ADDENDUM 03

PROJECT: RFP24-012 - Ben Lomond High School Auditorium Remodel

PROJECT NUMBER: 230109

DATE: March 6, 2024

REFLECTED CEILING PLAN - AUDITORIUM

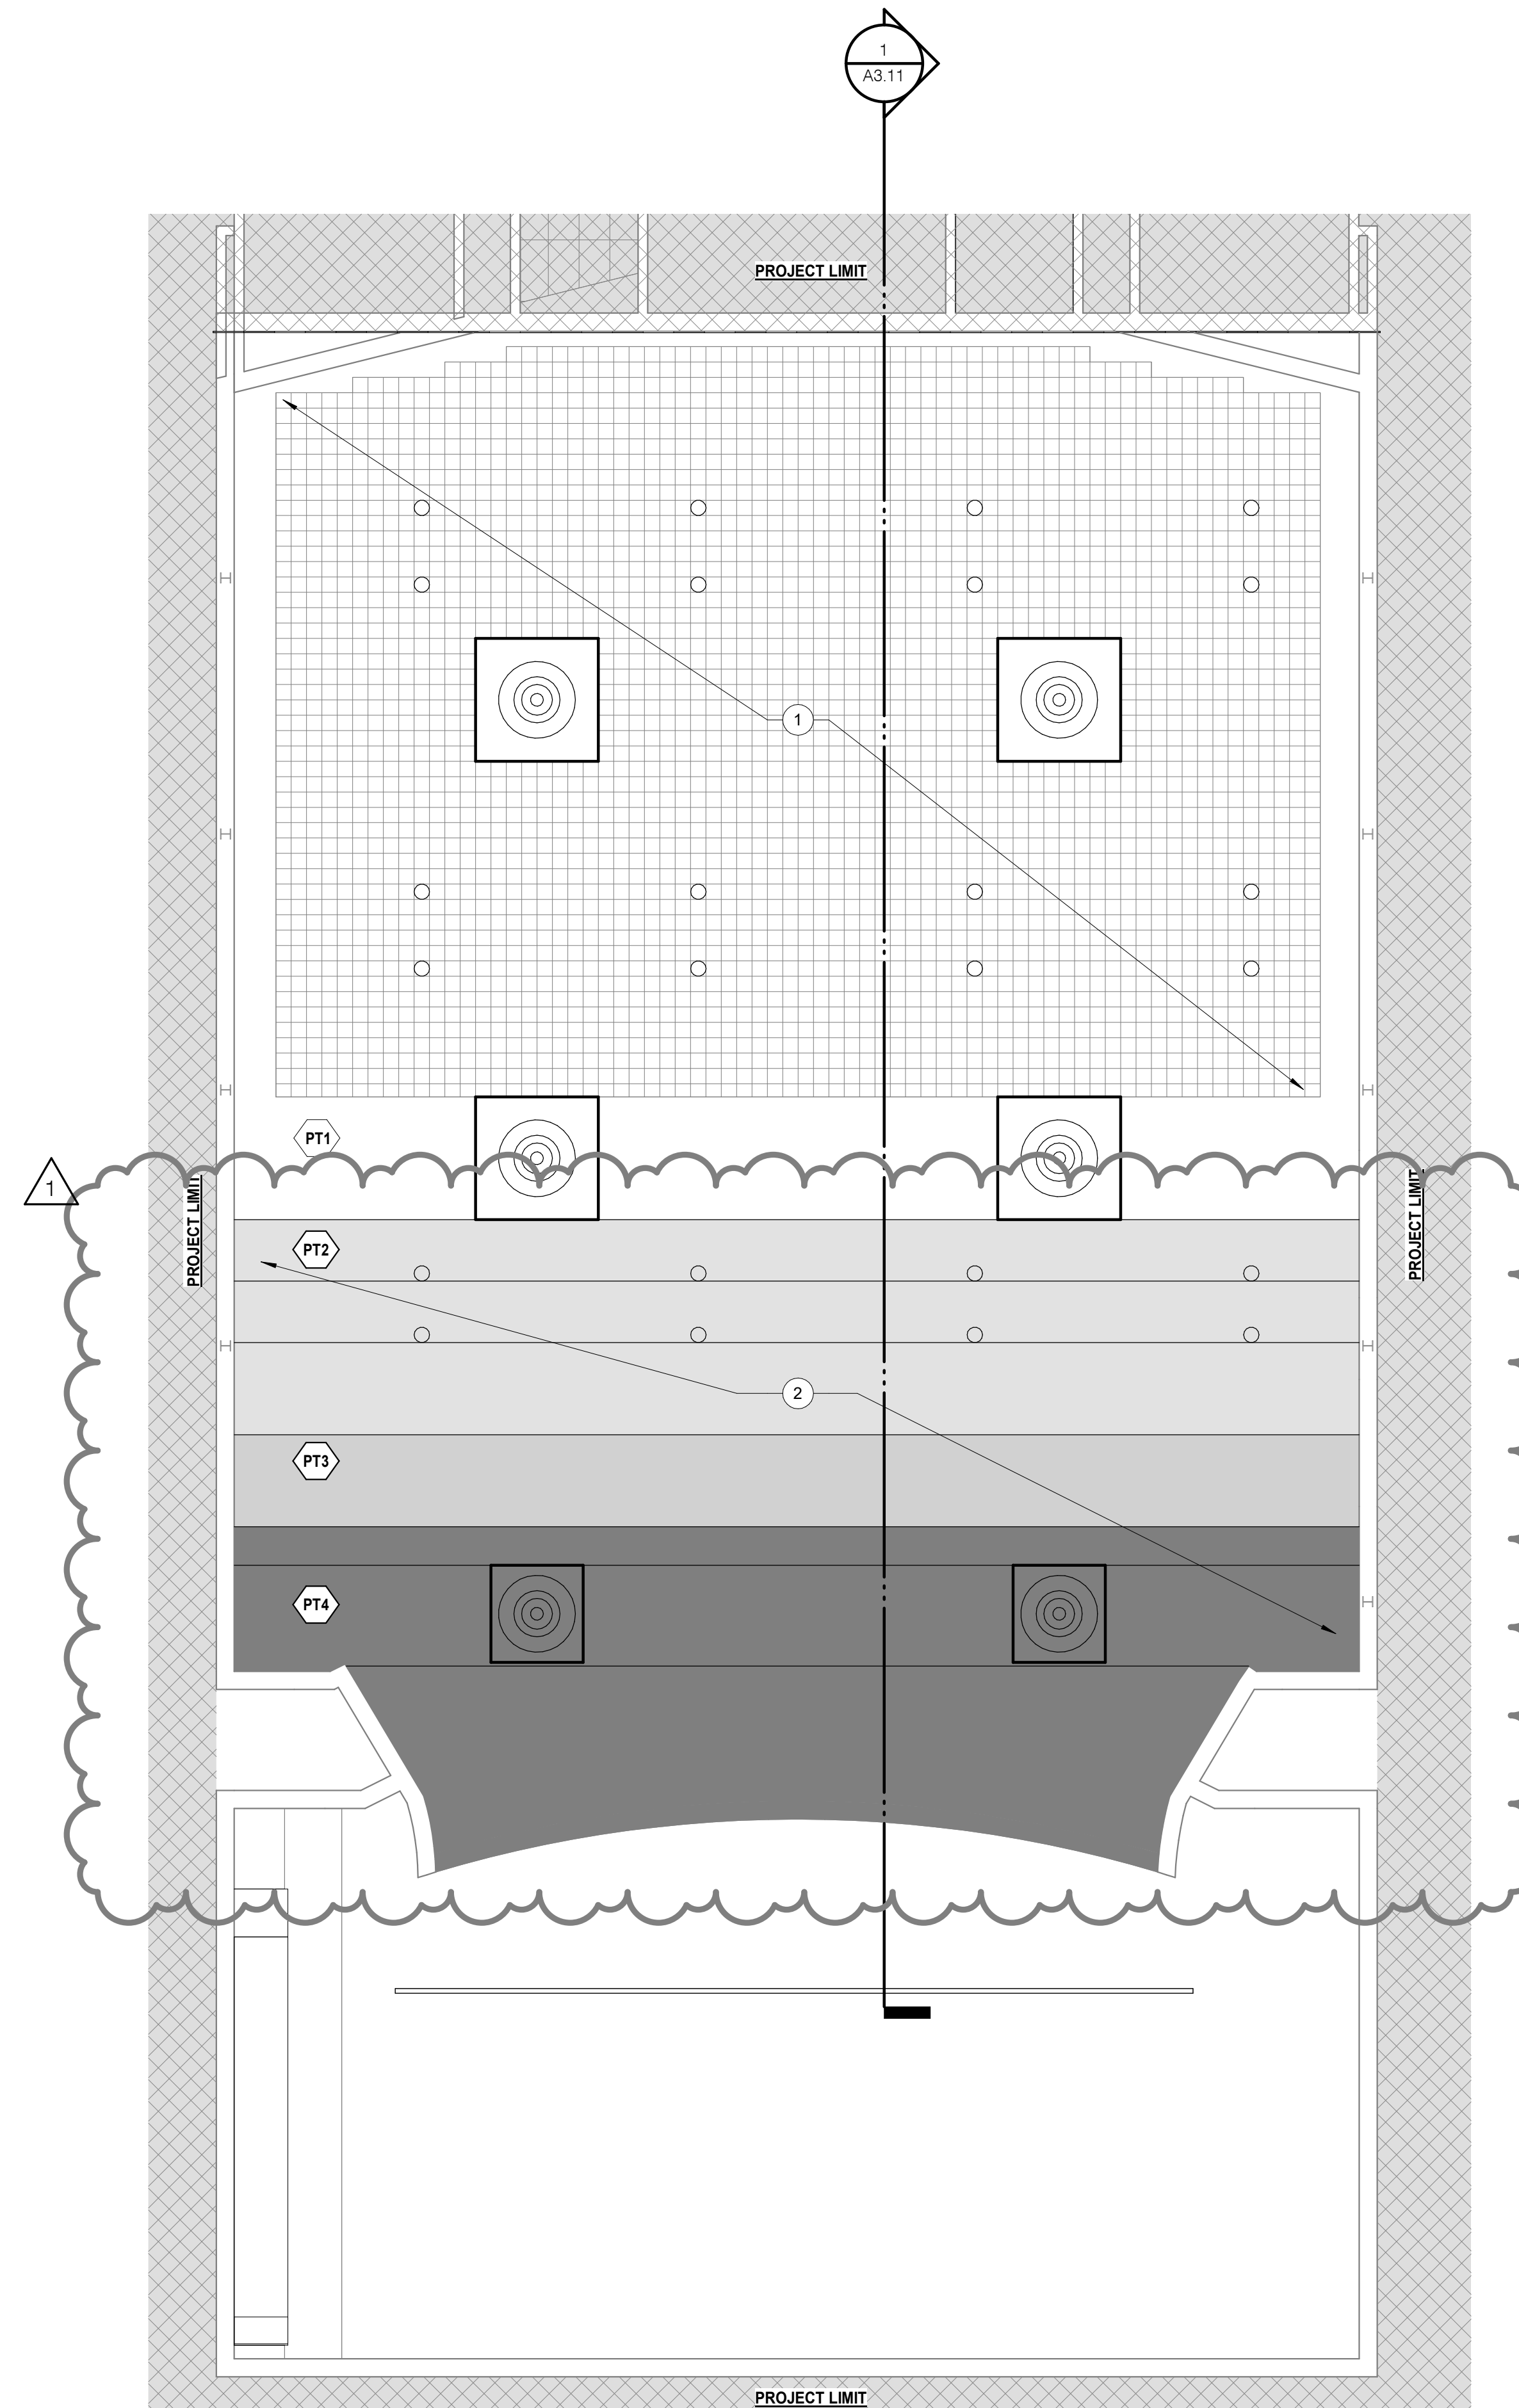
- Keynotes: **Added** keynote #2
- Add Alt #1 Auditorium Painting: **Added** narrative to clarify design intent
- Drawing A 'Reflected Ceiling Plan – Auditorium': **Revised** extents of section callout tag
- Drawing A 'Reflected Ceiling Plan – Auditorium': **Added** keynote #2

TICKET BOOTH ELEVATION - NORTH

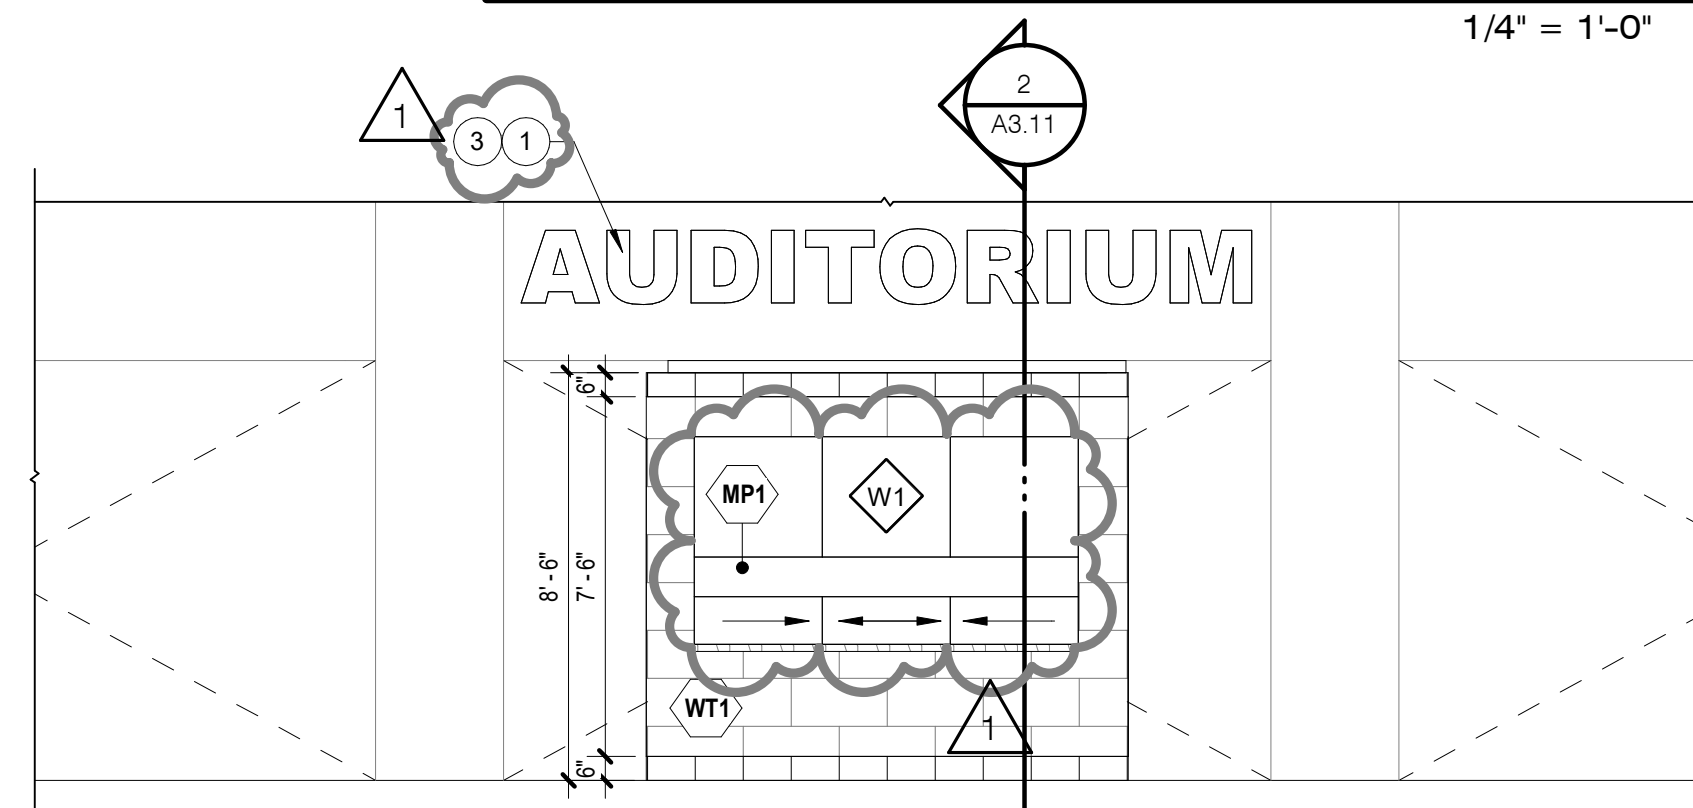
Q2: Sheet IA1.21, Finish Schedule, MP1 - The notes note that this is by GC and to reference Sheet A2.21, Detail 10 - This detail does not exist. Are metal panels used on this project, I am not finding where it is called out?

Q17: Can you provide a specification to the "AUDITORIUM" signage? Material, finish, size, etc.?

- Keynotes: **Added** keynote #3
- Drawing 1 'Ticket Booth Elevation – North': **Added** keynote #3
- Drawing 1 'Ticket Booth Elevation – North': **Added** material tag 'MP1'
- Drawing 2 'Ticket Booth Elevation – East': **Revised** storefront system 'W2'
- Drawing 4 'Ticket Booth Elevation – West': **Revised** storefront system 'W2'

*A2: This question will be addressed with revised drawings that will be issued as Addendum 03:
[Please see revised sheet A2.21]*

A17: "AUDITORIUM" Signage is to be 20" Tall Brushed/Natural Satin finish Aluminum Letters that are ¼" Thick and attached with a ¼" standoff. Contractor will field verify actual size, finish, and attachment and

- 1 NEW 'AUDITORIUM' SIGNAGE SIM. TO 'E-HALL' SIGNAGE IN PHOTO B/A2.21.
- 2 NEW SECURITY CAMERA. SEE ELECTRICAL DRAWINGS AND COORDINATE.
- 3 'AUDITORIUM' SIGNAGE IS TO BE 20" TALL BRUSHED/NATURAL SATIN FINISH ALUMINUM LETTERS THAT ARE 1/2" THICK AND ATTACHED WITH A 1/4" STANDOFF. CONTRACTOR WILL FIELD VERIFY ACTUAL SIZE, FINISH, AND ATTACHMENT AND COORDINATE NEW SIGNAGE TO MATCH EXISTING SIGNAGE. A SAMPLE WILL BE REQUIRED AS PART OF THE CONSTRUCTION SUBMITTAL.

SECTION - AUDITORIUM 1

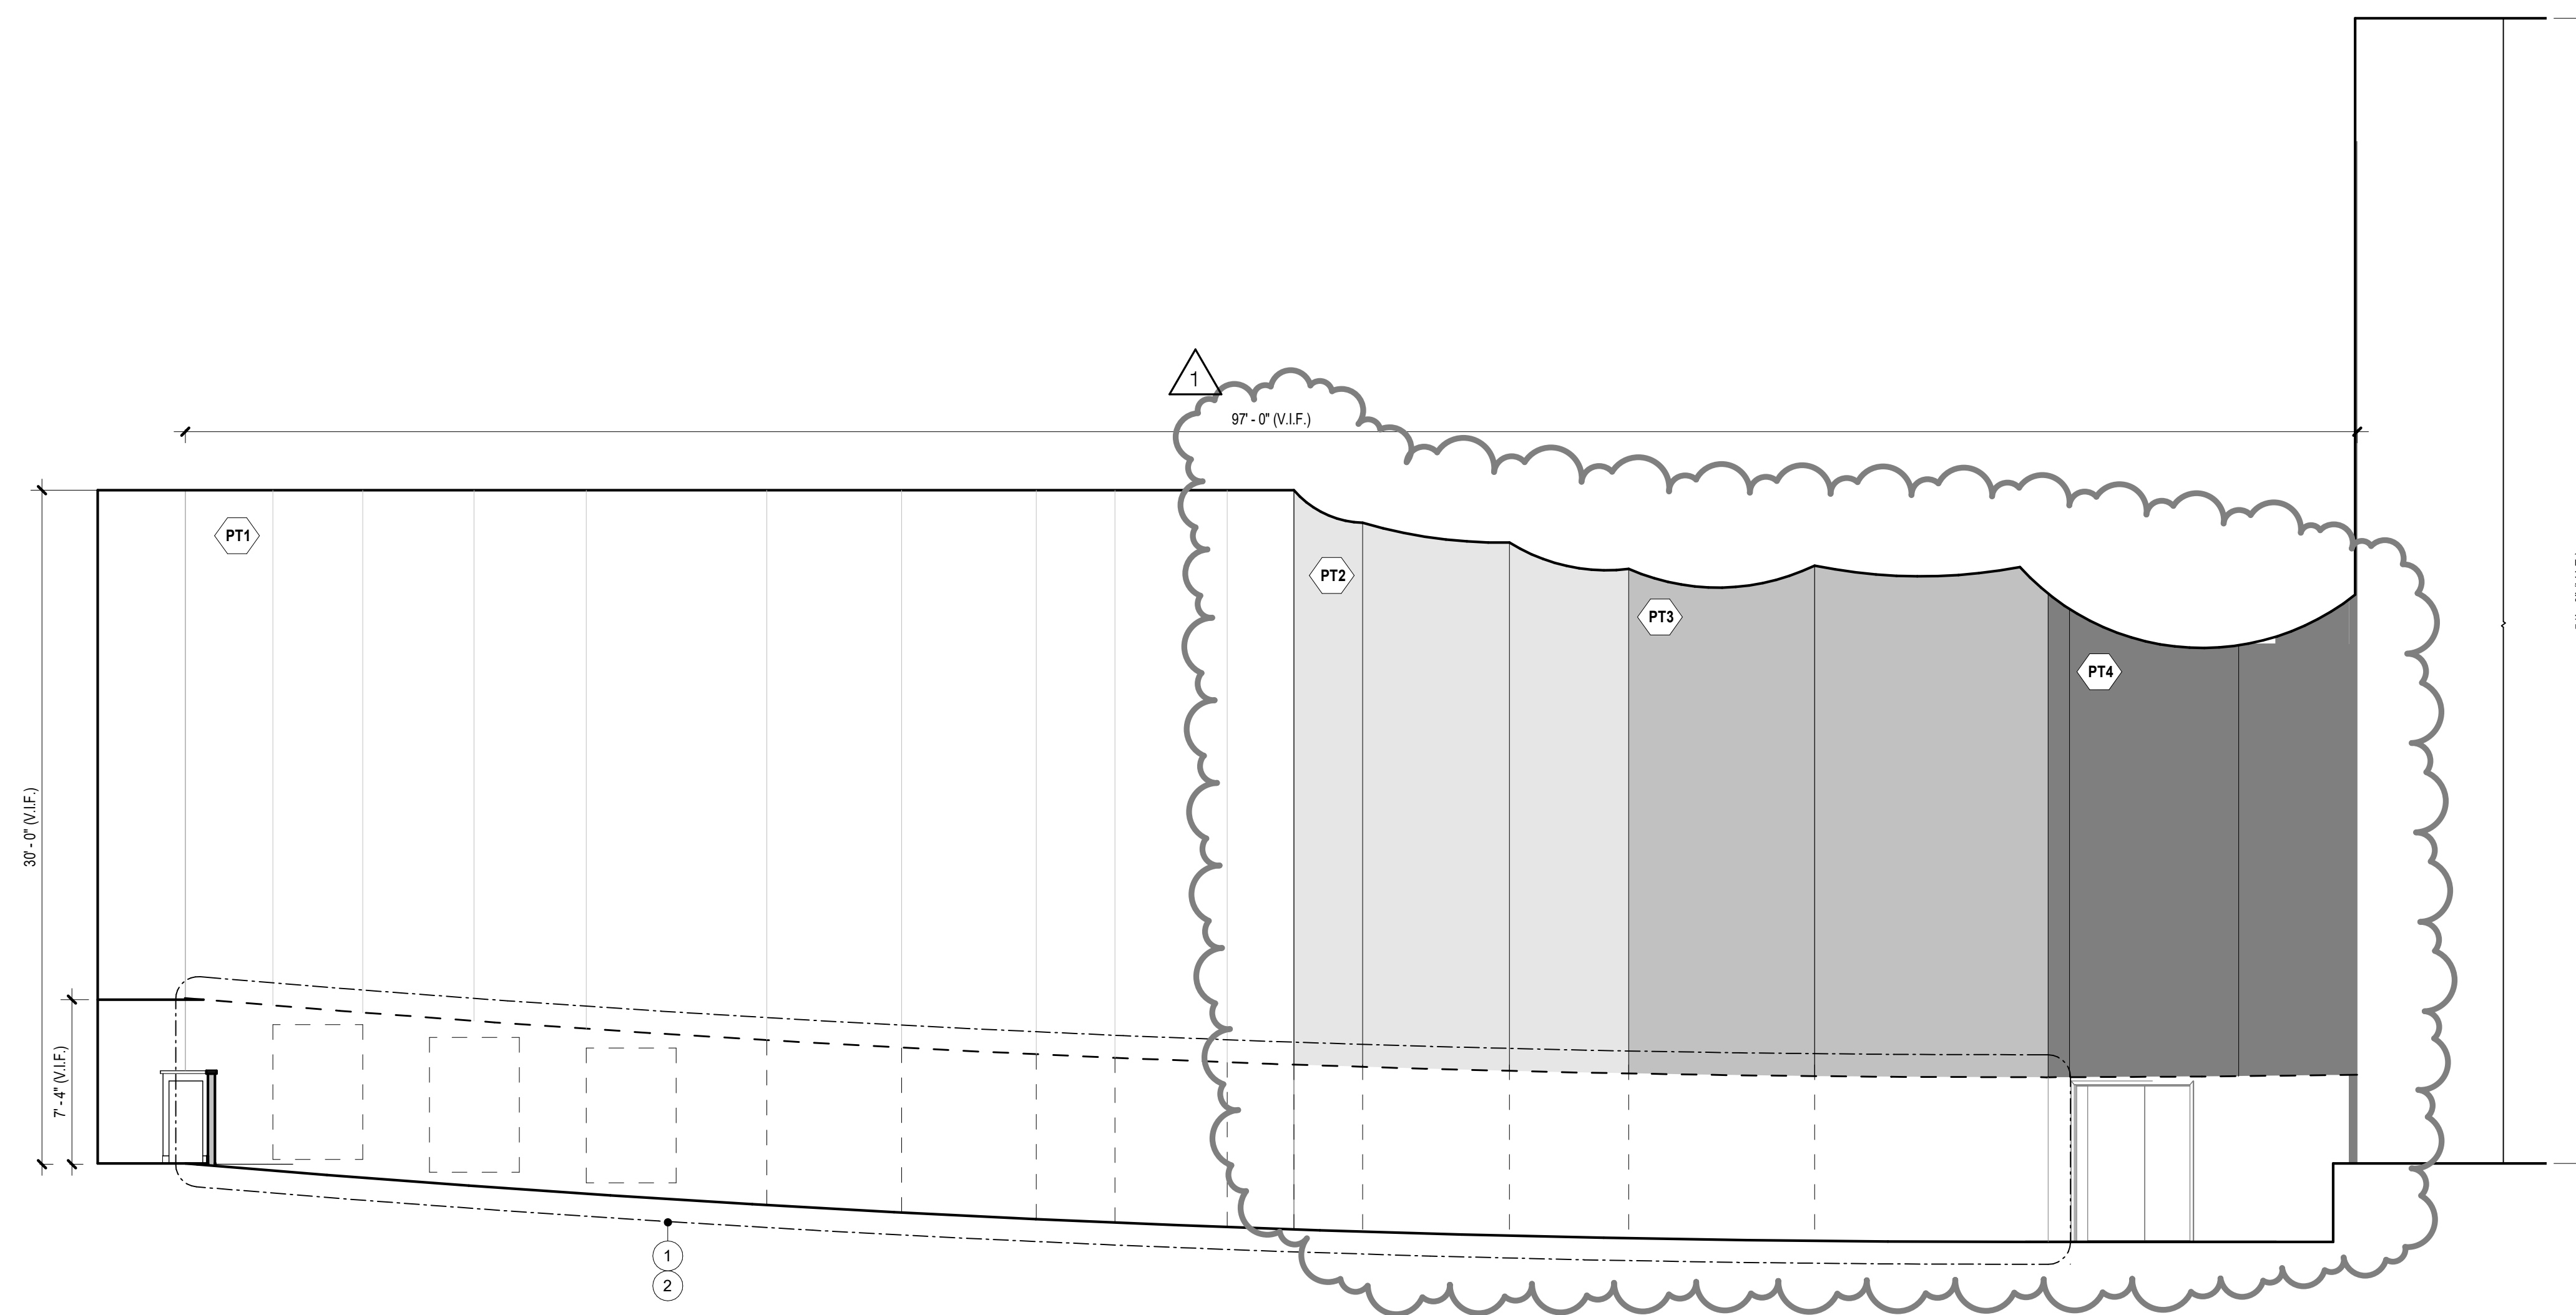
- Finish Legend: **Updated** graphics of finish legend
- Drawings 1 'Section – Auditorium': **Updated** extents of painting

DIAGONAL CROSS BRACING DETAIL ⑤
3" = 1'-0"

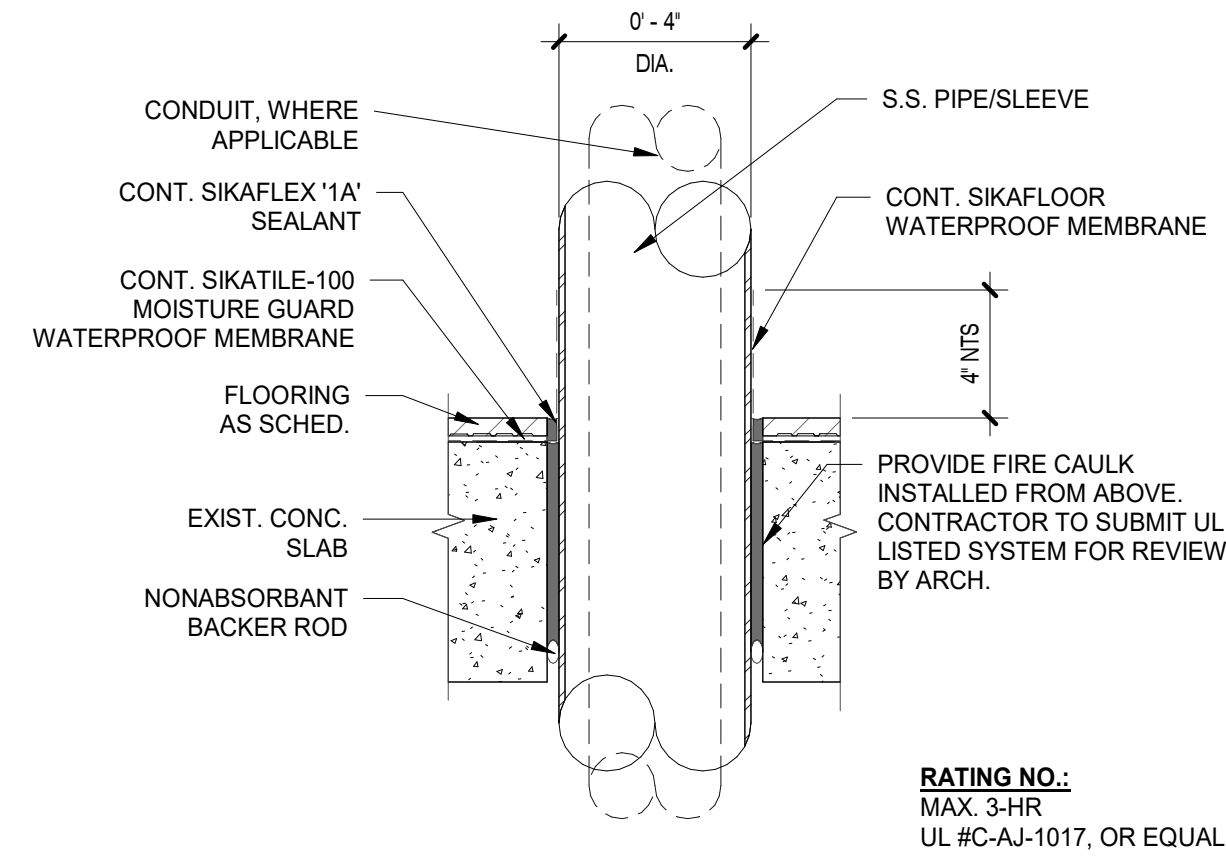
- Drawing 2 'Ticket Booth Section – Wall Section thru Storefront: **Updated** text note reference
- Drawing 3 'Ticket Booth Section – Wall Section @ Ticket Counter': **Updated** wall section detail
- Drawing 5 'Diagonal Cross Bracing Detail': **Added** drawing to sheet
